APPENDIX H

**ALCOVE 8–NICHE 3 TESTING AND PRETEST PREDICTIONS
(RESPONSE TO RT 3.05, SDS 3.01 AIN-1, AND USFIC 6.03)**

This appendix provides a response for Key Technical Issue (KTI) Agreements Radionuclide Transport (RT) 3.05, Structural Deformation and Seismicity (SDS) 3.01 Additional Information Needed (AIN)-1, and Unsaturated and Saturated Flow under Isothermal Conditions (USFIC) 6.03. These agreements relate to (1) the documentation of the Alcove 8–Niche 3 (also referred to as Niche 3107) testing and predictive modeling for the unsaturated zone, (2) the fracture-informed observation of infiltration and seepage related to observed fracture patterns, and (3) the responses to NRC staff comments on the Alcove 8–Niche 3 tests and pretest predictions.

Figure H-10. Correlation between the (Normalized) Measured Infiltration Rates during (a) the First 90 Days and (b) the Later 125 Days, and Fractures Density Calculated for Each of the Subplots at the Floor of Alcove 8

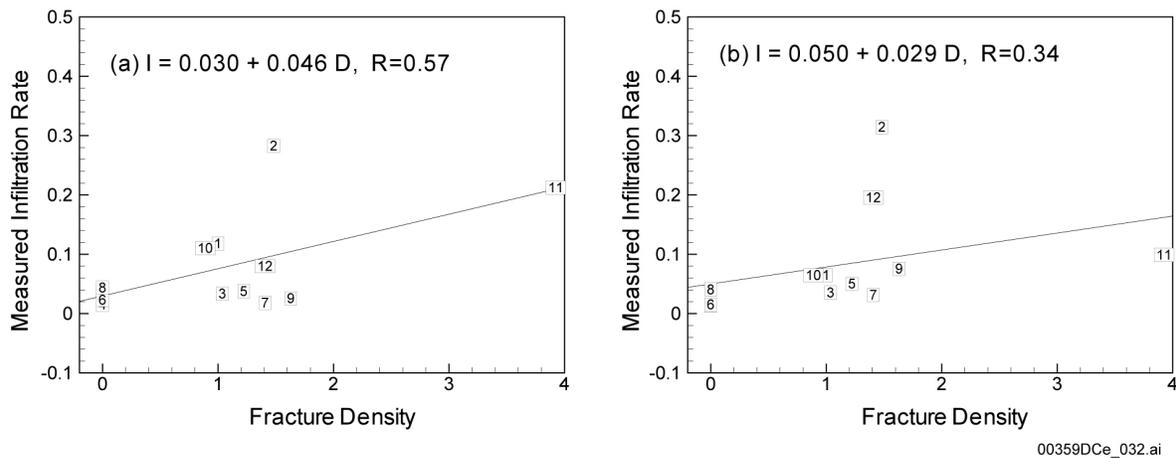
In response to the SDS 3.01 AIN-1, a fracture-informed analysis was conducted using the measured infiltration and seepage rates based on the fracture maps on the alcove floor and niche ceiling. The following findings were obtained:

- A positive correlation between measured infiltration rates and calculated fracture density was obtained. The measured infiltration rates reflected the effects of the total actively participating fractures (and fracture segments); the calculated fracture density includes active fractures (and segments) and inactive ones. The positive correlations demonstrate that discrete fractures in the large infiltration plot played a critical role in water percolation. However, the correlations were weakened by in-fracture-plane heterogeneity and complicated dynamic effects. Therefore, capturing discrete features of a fracture network does not mean success in capturing complicated unsaturated flow.
